TECHNICAL STAFF REPORT

Case No./Petitioner: PB 420 – Montevideo Crossing Royal Farms
Mark Levy, MIT-Montevideo, LLC

Request: For the Planning Board to approve the Optional Design Project (ODP) in a Commercial Redevelopment (CR) Overlay District for Royal Farms at Montevideo Crossing in accordance with Section 121.1.H of the Zoning Regulations.

Exhibit C

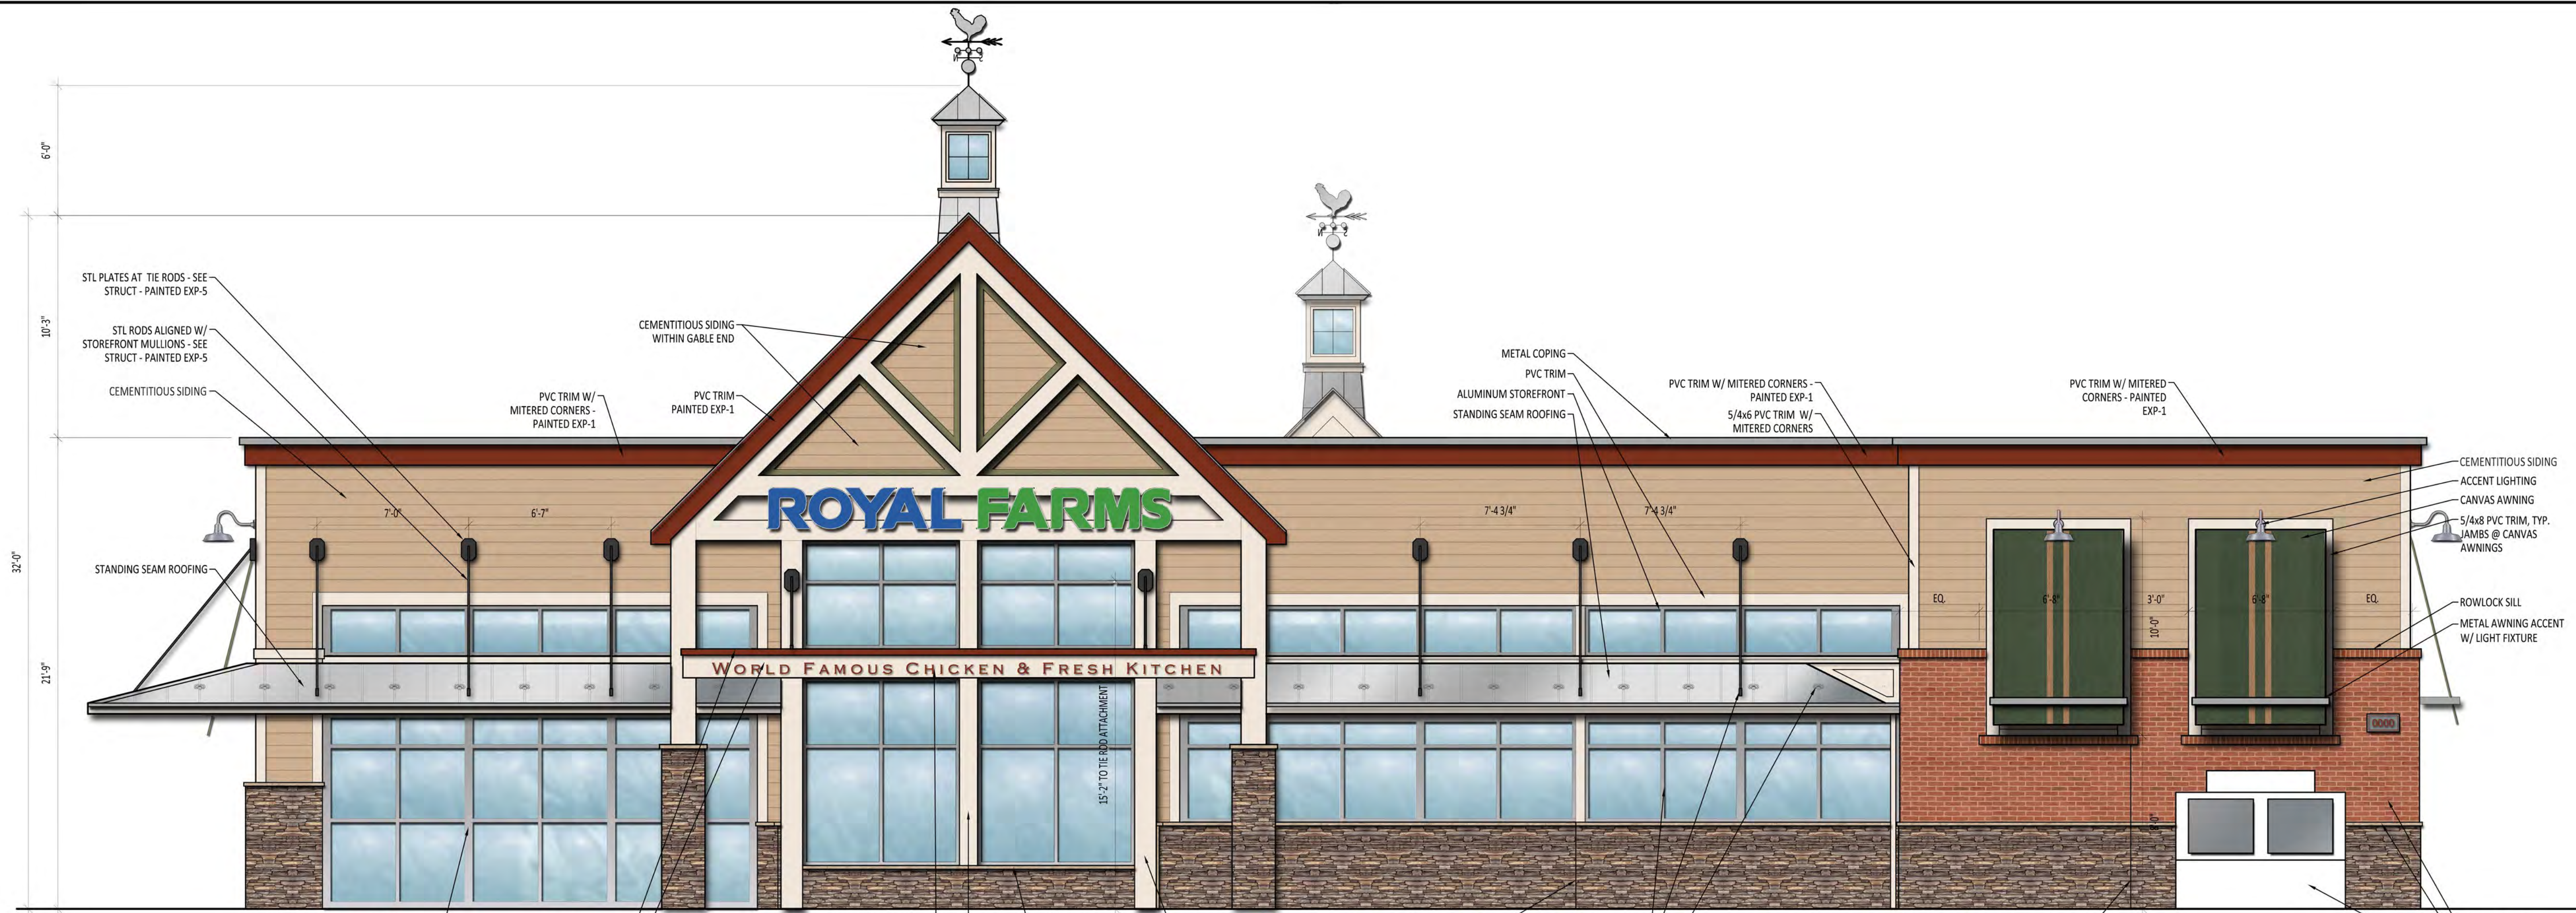
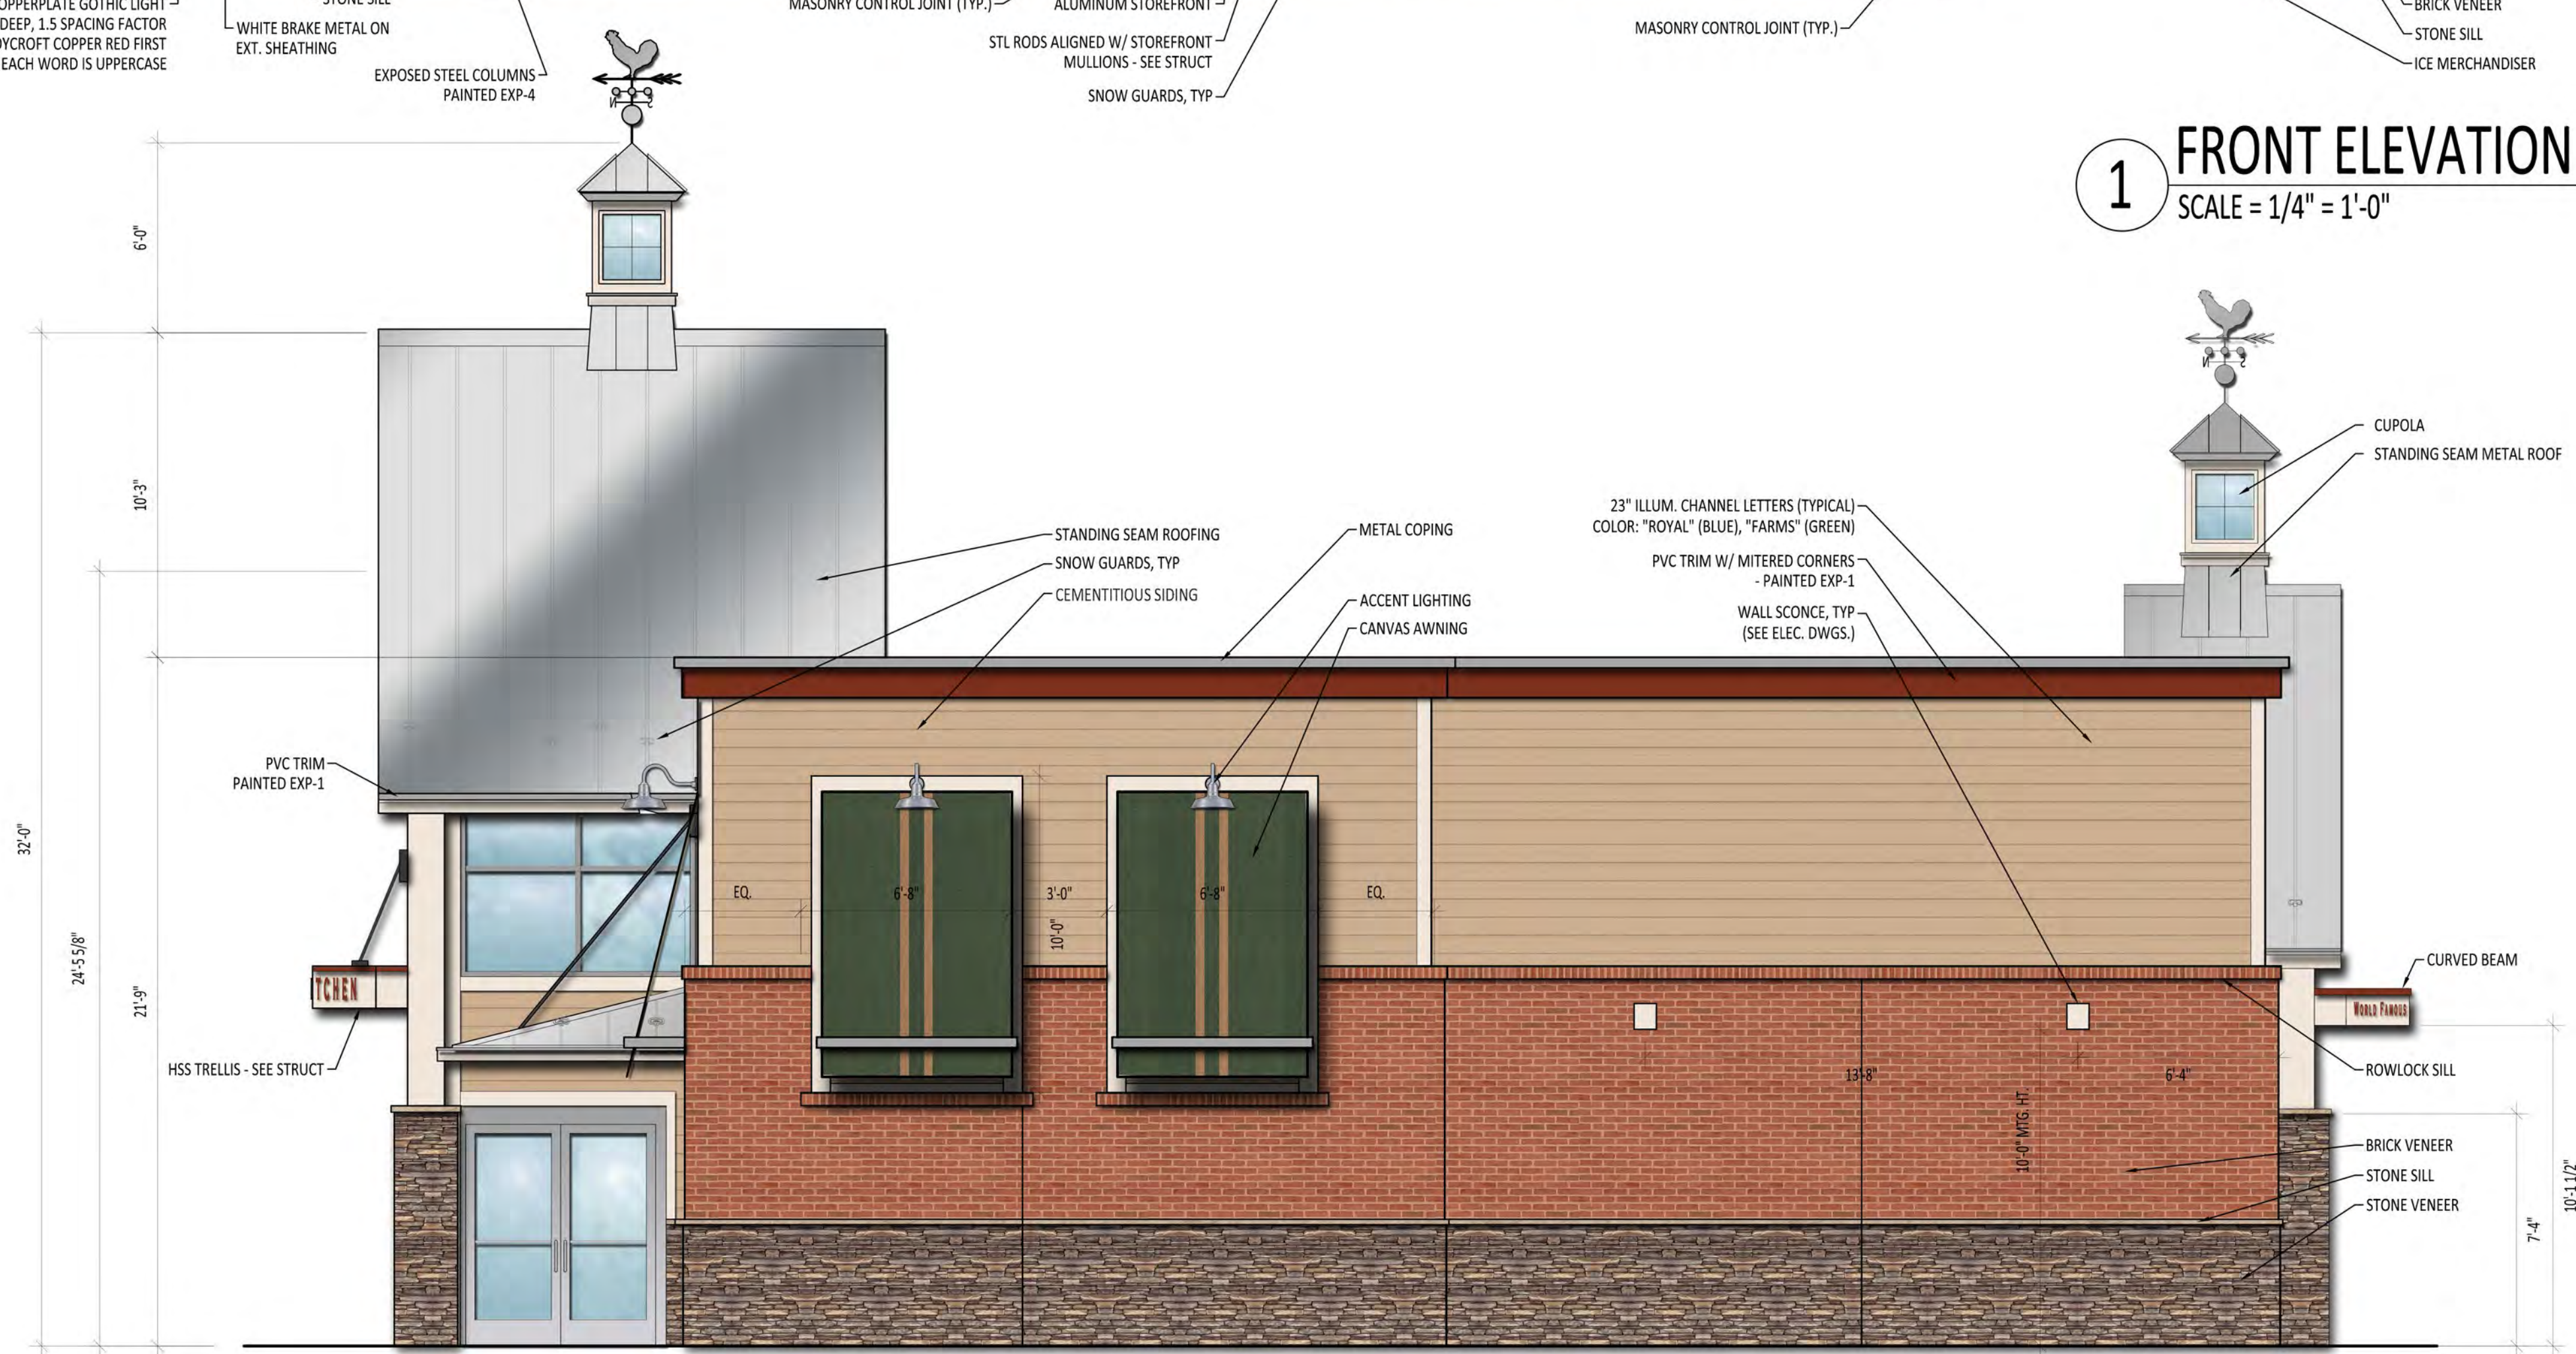
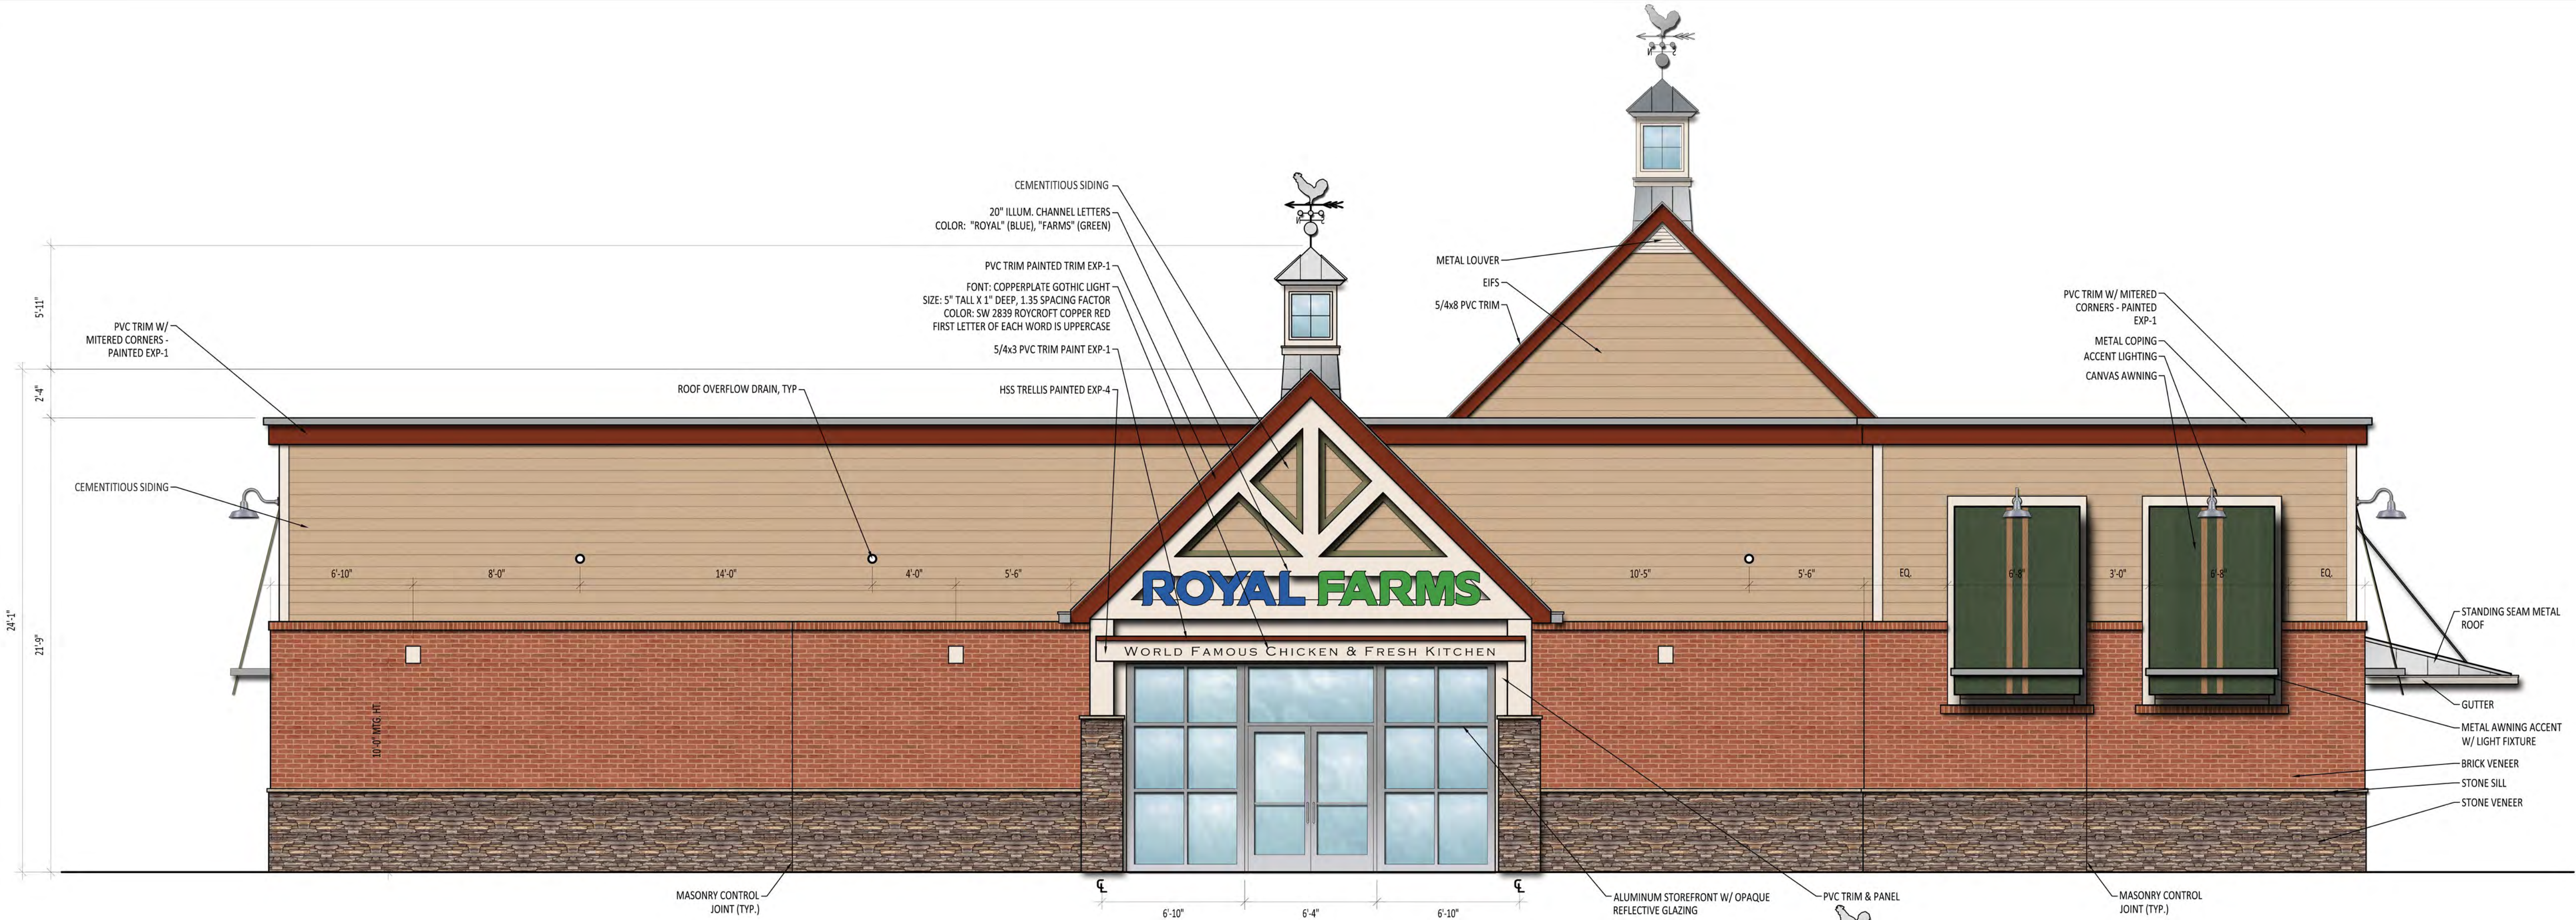
Royal Farms altered their standard architecture to better match that of the CVS, thereby visually connecting the two buildings and creating a unified theme. Brick color will match, siding will match the top band of CVS' exterior insulation and finishing system (EIFS), and white trim board will correspond with CVS' peach colored EIFS. See Appendix C.
